Application for Licence Amendment

| Licence Number | L8422/2010/2 |
| Premises | Edna May Gold Project Warrachuppin Road WESTONIA WA 6423 Legal description – Within mining tenements M77/88, M77/110, M77/124, G77/122 and L77/18 |
| Date of Report | 10 June 2025 |

Figure 1: Proposed new landfill areas (highlighted in yellow)

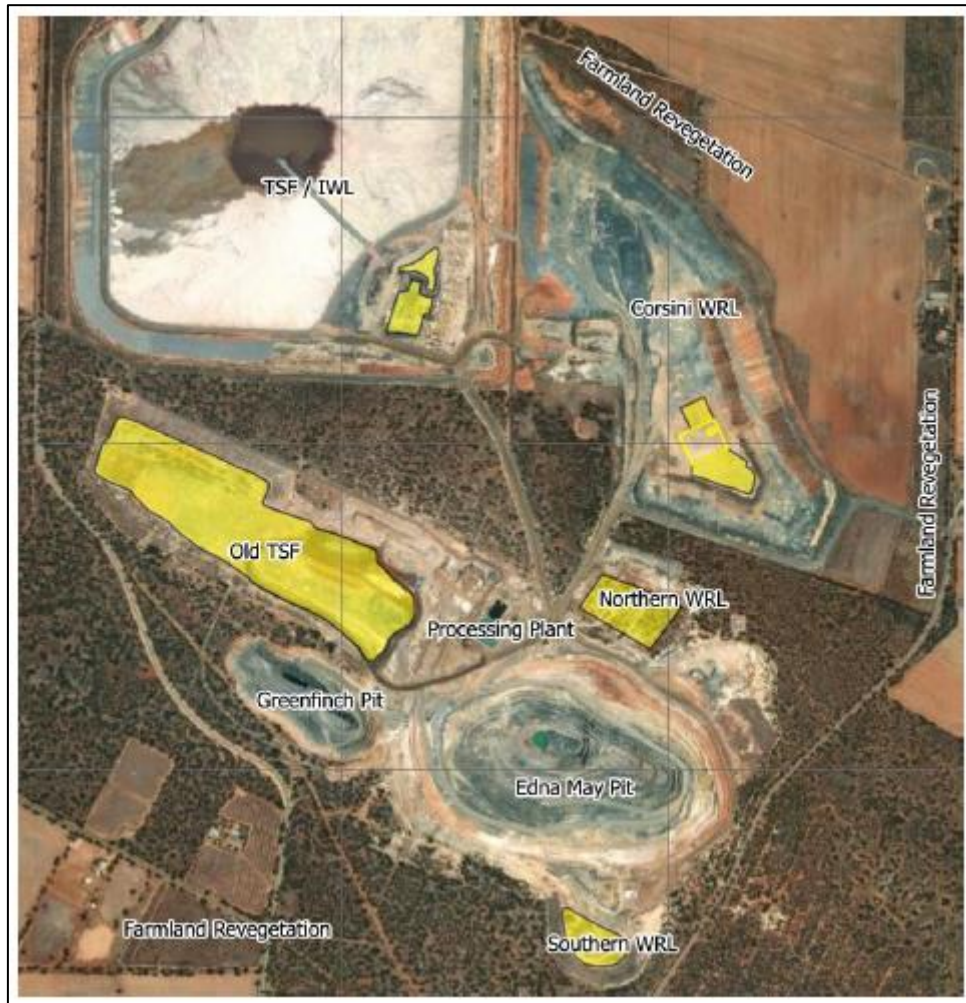
The licence holder is seeking approval to expand landfilling on the premises by constructing new landfill areas and increasing the current authorised annual throughput for managing waste from decommissioning of the premises. New landfilling areas are proposed within the historic Tailing Storage Facility (TSF) area, on top of the Southern Waste Rock Landform (Southern WRL), Northern WRL and unused sections of the Edna May TSF. The licence holder is also proposing to expand the current landfilling area to the north-northwest and southeast of the current extent (Figure 1).

The licence holder has stated that the intention is not to use the entire proposed area but instead have multiple disposal area options for flexibility. The existing landfill area will continue to be used for the burial of general and putrescible waste with the new locations being used to dispose of only large solid waste. The proposed plan is to primarily bury waste in the current Run of Mine (ROM) and historic TSF with the additional landfill areas proposed to be used only on an as needed basis.

Used tyres will be buried at the TSF/IWL area (Figure 1 above). The expected final volume of tyres is approximately 116 loader / haul truck tyres and 80 light vehicle tyres. Waste tyres are expected to be delivered once or twice a week with tyre burial operations continuing until all tyres are buried and activity on the site has ceased.
